**SUBJECT: RECALL CAMPAIGN #80917
2008/2009 Tioga Ranger and Jamboree Sport - Holding Tank Straps**

Recall Bulletin 80917

RECALL BULLETIN:
80917

SUBJECT:
Correction of holding tank straps and inspection/correction of tank plumbing

Figure 1

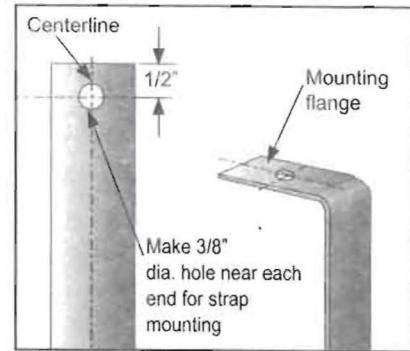
- Remove the original tank strap and discard the lock nuts and washers used to mount it. Measure the length of the original strap. The replacement strap will need to allow for a 1" mounting flange at one or both ends, where required for installation. See Figure 1. Make note of length needed, then discard the old strap.

- Cut a piece of new strap according to the measurement noted in Step 6, then use a center punch or drill to make a hole near each end, for installation onto the original strap mounting bolt. Each hole is to be centered on the strap material, 1/2" from the end. See Figure 1.

- Where required for installation:** Bend approximately 1" of each end of the new strap to make a mounting flange. Make a smooth radius at the bend as specified in Step 9. Avoid a sharp (90°) angle. Verify there are no sharp edges, cracks, or tears in the material. See Figures 1, 3, and 5.

Figure 2

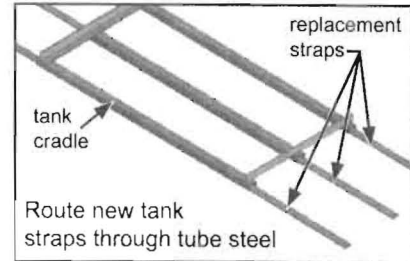
- Feed a replacement steel strap through the opening in the tank cradle's tube steel until it exits the opposite side. See Figure 2.
- Bend the strap upwards, making a smooth radius at the bend and avoiding a sharp (90°) angle. It may be helpful to use a piece of 3/8" round steel stock to achieve a smooth corner radius. Do not hammer the strap. Verify there are no sharp edges, cracks, or tears in the material. See Figures 3 and 4.
